UNITED STATES PATENT AND TRADEMARK OFFICE

APPLICATION NO.	FILING DATE	FIRST NAMED INVENTOR	ATTORNEY DOCKET NO.	CONFIRMATION NO.
10/789,078	02/27/2004	Steven J. Wygant	BEL0005.US	7269

Office Action Summary	Application No.		Applicant(s)	
	10/789,078		WYGANT, STEVEN J.	
	Examiner		Art Unit	
	Troy Chambers		3641

DETAILED ACTION

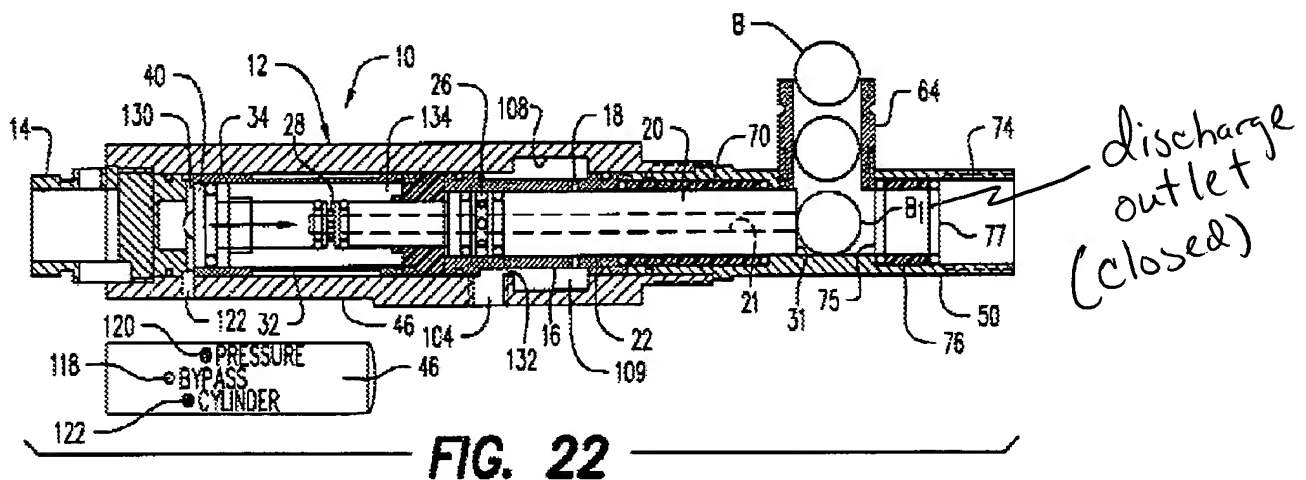
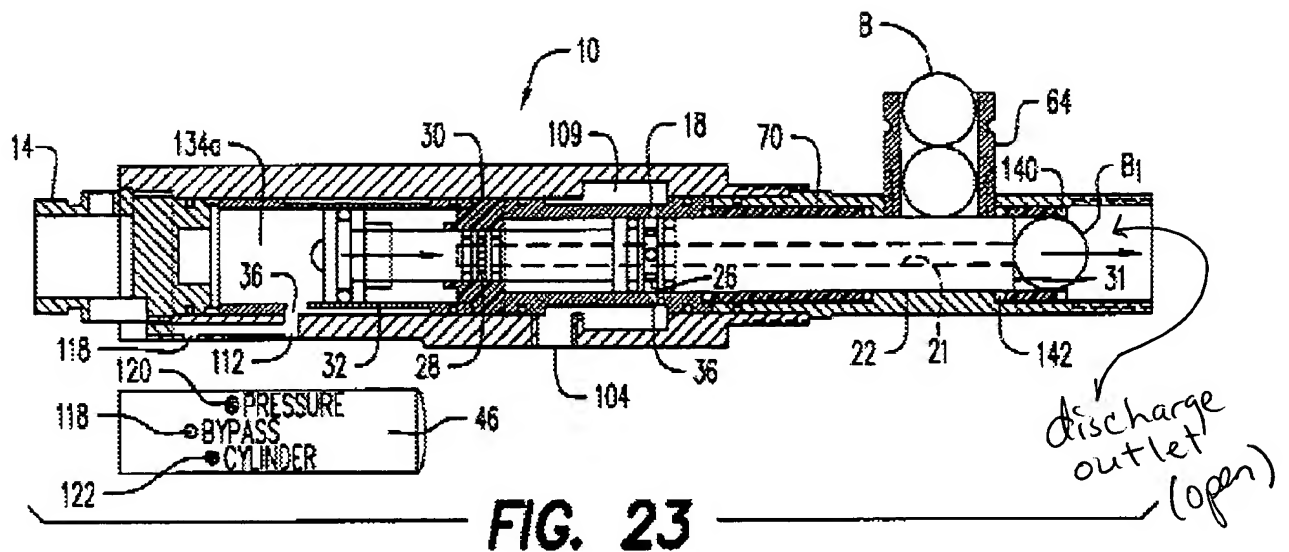
2. Claims 1-5, 7-9 and 12-14, 17, 18 and 20-22 are rejected under 35 U.S.C. 102(b) as being anticipated by U.S. 5769066 issued to Schneider. Schneider discloses a pneumatic shooting device 10.

3. With respect to claim 1, Schneider discloses a pneumatic shooting device comprising:

- a. a barrel 72;
- b. an action including:
 - i. a housing 12,
 - ii. a pressure reservoir 109,
 - iii. a discharge outlet see Fig. above
 - iv. a linear body 32,
 - v. a piston 40.

Upon return of the piston to the reward position, the discharge outlet is closed to a source of pressurized gas (col. 5, ll. 66 to col. 6, ll. 6).
